Re: Project# P-23-006 (SDP) & P-23-017 (SEPA)
Project Address 3619 Evergreen Pt Rd
Contact Evan Wehr
Contact Phone (509) 969-1994
Contact Email evan@eccodesigninc.com

Below are our responses to your comments in your letter dated August 10, 2023. Your original comments are in bold italics followed by our response in plain text.

PROJECT DESCRIPTION:
REMOVE AN EXISTING PIER AND TWO JET-SKI
LIFTS. CONSTRUCT A NEW PIER. INSTALL A
BOAT LIFT, A PLATFORM LIFT (210 SQ. FT.), AND
A PLATFORM JET-SKI LIFT (210 SQ. FT.). PLANT
NATIVE VEGETATION PER THE PLANTING PLAN.

PROPOSED SITE PLAN

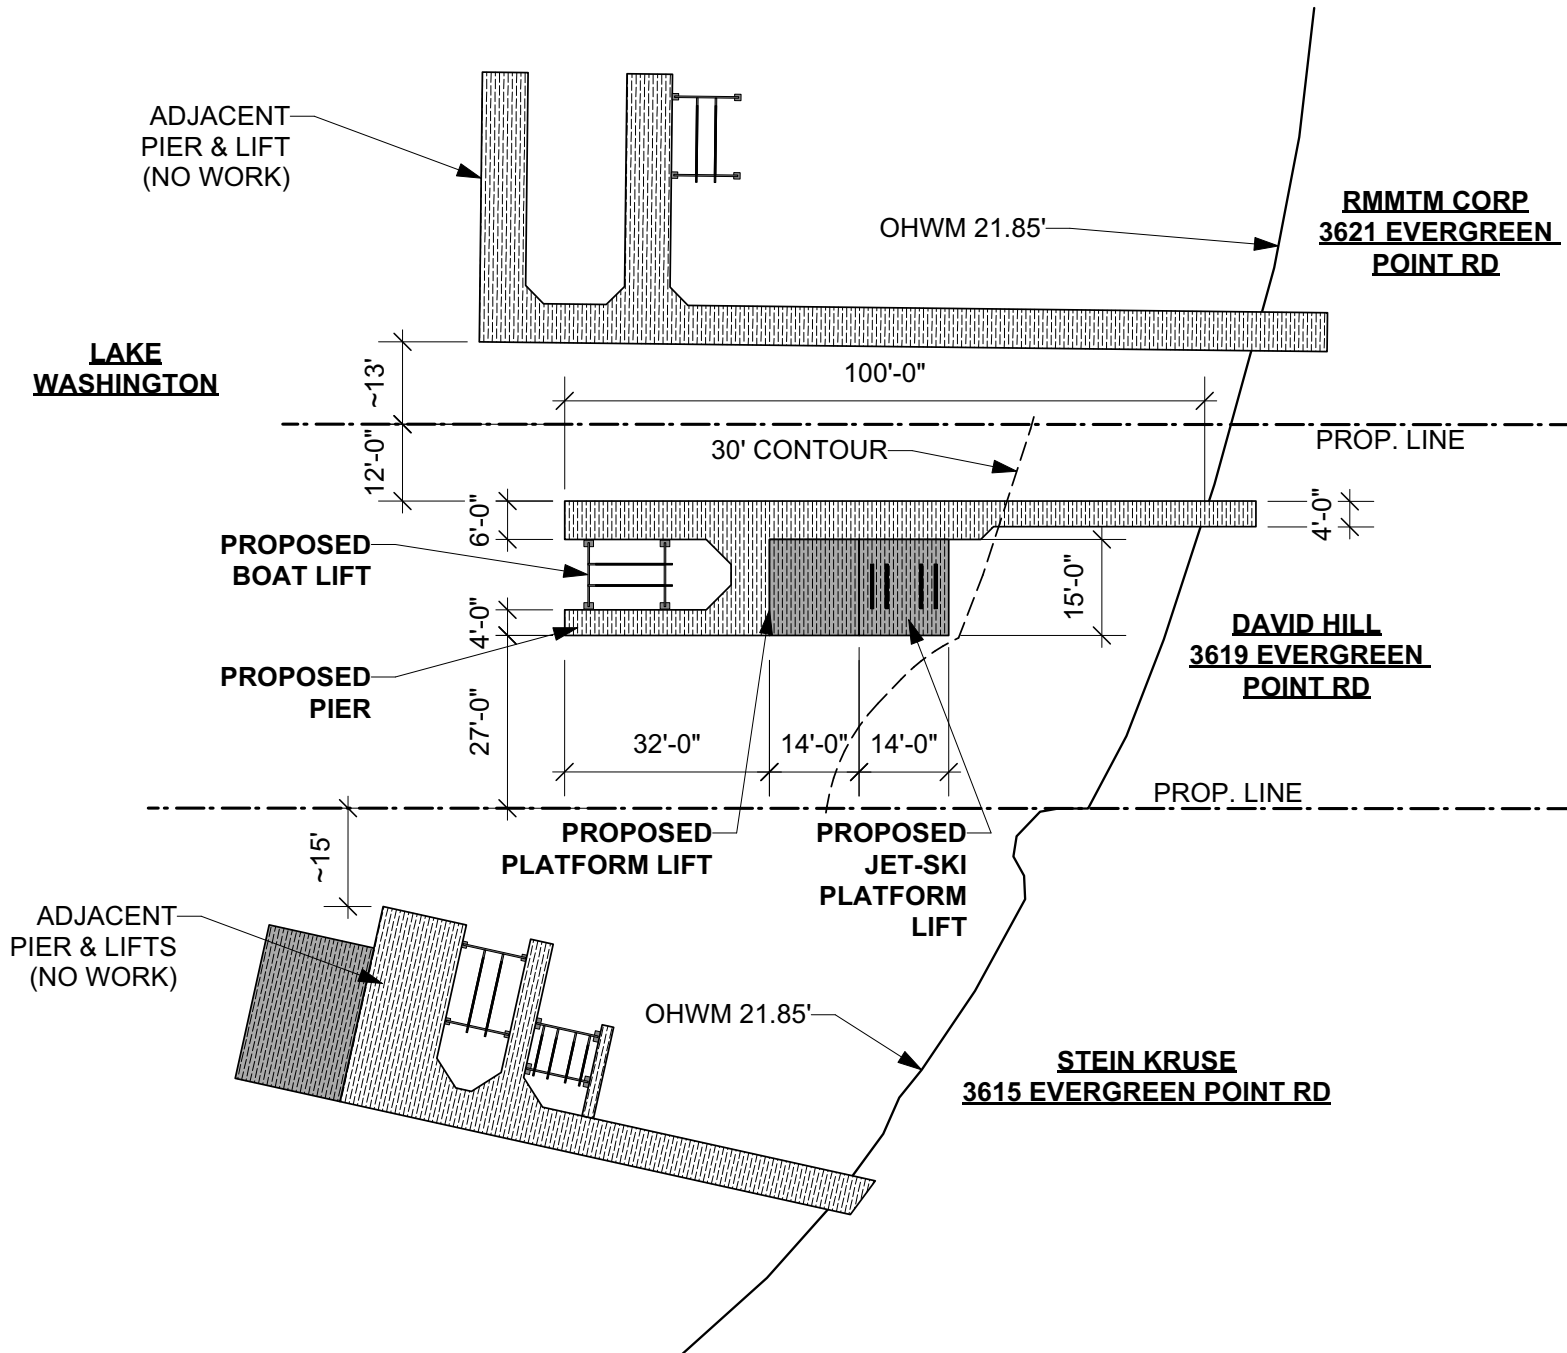
1. Upon review of the proposed jet skis, it appears that one of them is too close to the ordinary high-water line. Medina's code requires a minimum distance for all lifts to be not less than 30 feet from the ordinary high-water line (MMC Table 16.65.080). Please amend the location of the lift to be compliant with this code provision.

The platform jet-ski lift is greater than 30' from the ordinary high water mark as proposed. I have added a 30' contour to sheet 4 to show that the lift is waterward of 30' from the ordinary high water mark.

PLANTING PLAN

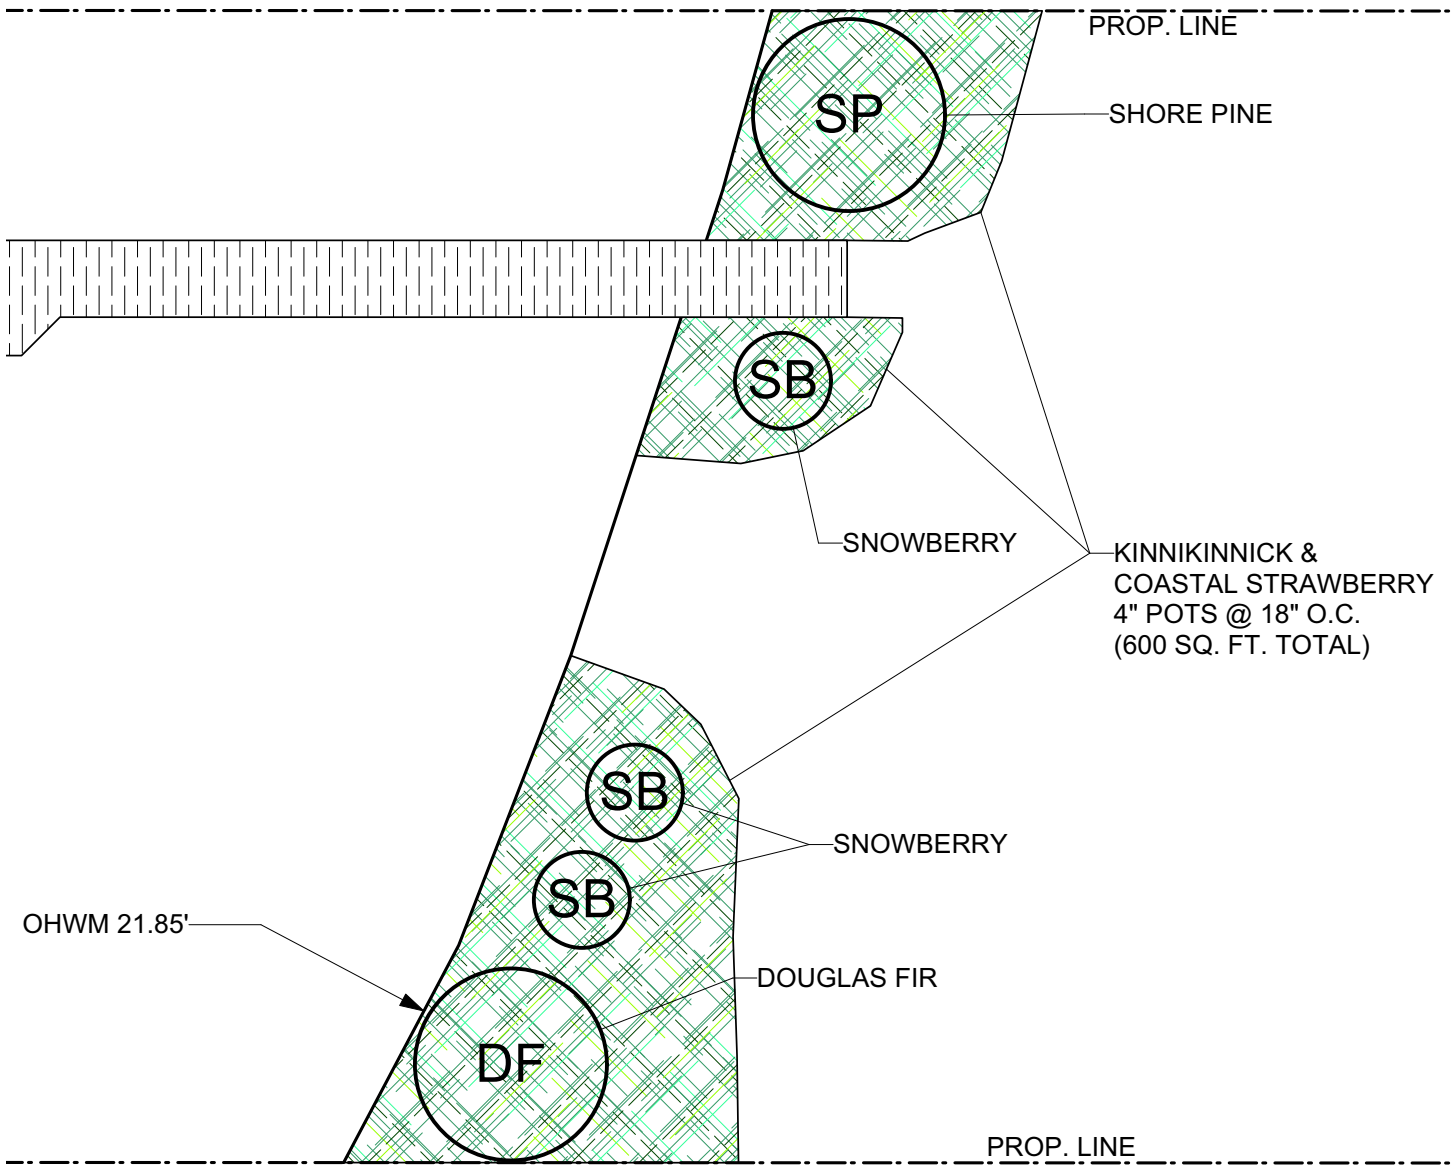
1. Planting Plan: Per MMC 16.65.040.E, when a new dock or pier is established, emergent vegetation waterward of the ordinary high-water line per Washington State Fish and Wildlife and/or Corps of Engineers requirements must be established along with a riparian vegetative planting area. The planting plan included in both submittals does not have emergent vegetation waterward of the ordinary high-water line.

Planting plans prepared by a qualified professional are also accepted per MMC 16.65.040.E. All planting plans must include maintenance and monitoring programs including:

- 1. An outline of the schedule for site monitoring***
- 2. Performance standards with 100 percent survival of newly planted vegetation within the first two years of planting, and 80 percent for years three and more***
- 3. Contingency plans identifying courses of action and any corrective measures to be taken if monitoring indicates performance standards are not being met***
- 4. The period of time necessary to establish performance standards has been met, not to be less than three years; and***

Neither WDFW nor the A.C.O.E. require emergent vegetation to be planted waterward of the ordinary high water line for projects like this on Lake Washington. I consulted with Northwest Environmental Consulting (the preparer of the NNL report for the project) regarding the feasibility of establishing emergent vegetation at the site. Their conclusion is that it would be highly difficult to do so due the existing loose gravel substrate at the site. Emergent vegetation needs a muddy substrate to be able to establish. Loose gravel substrates constantly churn from wave action and prevent emergent vegetation from taking hold. The site gets a lot of wave action from boat wakes and storms due to the location and the fetch. Emergent vegetation will naturally establish in areas with the right conditions. Since currently there is none at the site it indicates that it is unlikely to be able to be established. We are currently not proposing emergent vegetation for the project.
